**SUBJECT: Transmittal of Revised Responses to AP1000 DSER Open Items**

**AP1000 Design Certification Review  
Draft Safety Evaluation Report Open Item Non-Proprietary Responses**

**DSER Open Item Number: 3.8.2.1-1 Revision 3**

**Figure 1 Event Tree Model and Calculation of the Frequency of Scenario 1 (page 1 of 2)**

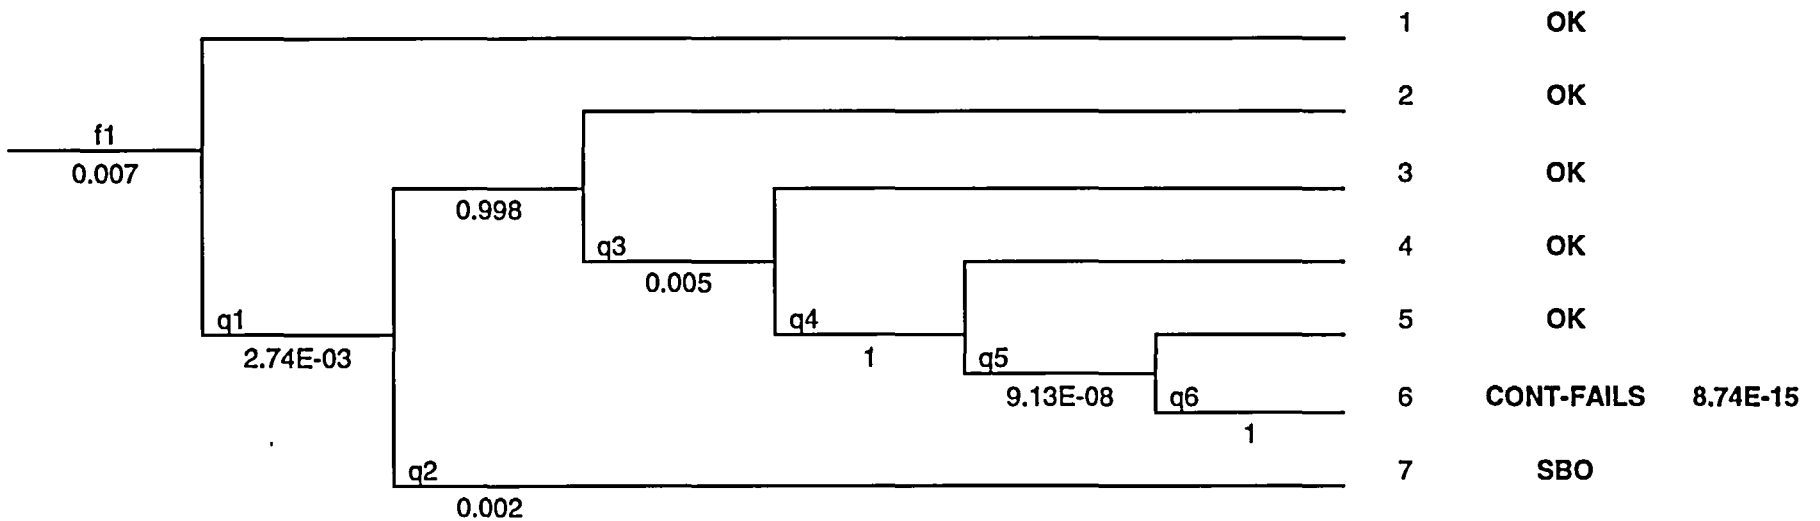
Provide the frequency quantification for combined external pressure scenario and SSE events that was discussed in the October 6-9, 2003, meeting.

Revision 3 of this response provides the requested quantification in the Attachment 3.8.2.1-1 R3-1. This information supplements the previous discussion of this topic that was provided in Attachment 1 to Westinghouse letter DCP/NRC1583 dated May 1, 2003.

Event Tree of Figure 1 models and defines the resulting event sequence. The sequence of interest to us is sequence #6 which is postulated to lead to containment failure. The station blackout (SBO) sequence is not further pursued here.

The following frequencies/probabilities are used for calculation of the frequency of sequence #6 in Figure 1:
